SJ50-03-S

S E R V I C E N O T E

Agilent SJ50 Optical Board Test System

POSSIBLE SHOCK HAZARD

Picture 1

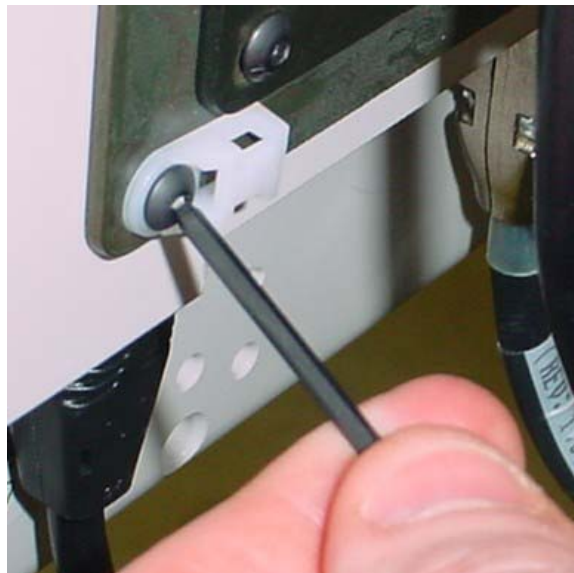
- 1) Remove the screws on the monitor back plate, see Picture 1.

Picture 2

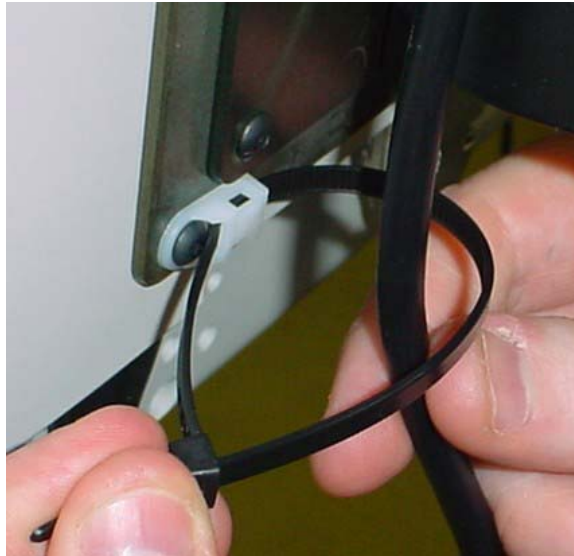
- 2) Using the screws supplied (5186-1448) attach cable tie cleats (5186-1707) to Monitor back plate, see Picture 2.
- 3) Fit Cable Tie Cleat for both the Power cord and monitor signal cable on each side of monitor.
